**PCN#20250608001.2**

**Qualification of CDAT as an additional Assembly/Test site for the Select Devices  
Change Notification / Sample Request**

**Date:** June 09, 2025

Sample product shipping label (not actual product label)

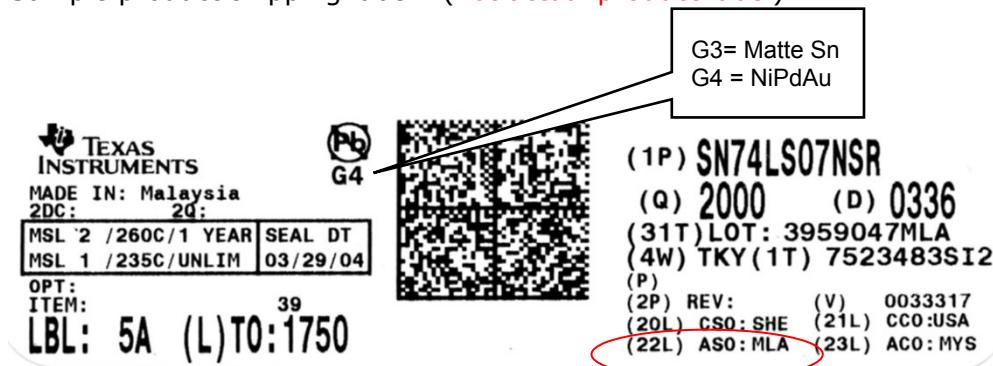
**Changes to product identification resulting from this PCN:**

Assembly Site	Assembly Site Origin (22L)	Assembly Country Code (23L)	Assembly City
HFTF	HFT	CHN	Hefei
HNA	HNT	THA	Ayutthaya
PHI	PHI	PHL	Baguio City
UTL2	NS2	THA	Bangpakong, Chachoengsao
<b>CDAT</b>	<b>CDA</b>	<b>CHN</b>	<b>Chengdu</b>
